1. COA-065088-2019

2701 East Grace Street

St. John's Church

Remove side deck and construct a rear addition.

Figure 1. 1905 Sanborn Map

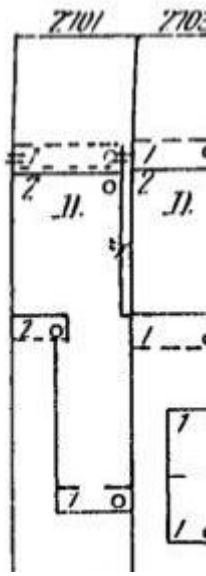
The proposed addition generally meets the Commission's guidelines for additions as it is subordinate in size to the main building and located at the rear. In addition, Sanborn maps indicate there was previously a small 1-story frame structure in this location, with an opening to the main house.
Standards for New Construction, Materials, pg. 47 #1-3	<ol style="list-style-type: none"> 1. <i>Additions should not obscure or destroy original architectural elements.</i> 2. <i>Materials used in new residential construction should be visually compatible with original materials used throughout the district.</i> 3. <i>Paint colors for new additions should complement the historically appropriate colors used on the primary structure.</i> 	The proposed materials and colors are visually compatible with original materials found throughout the building. The frame addition is also clearly differentiated from the historic brick building.
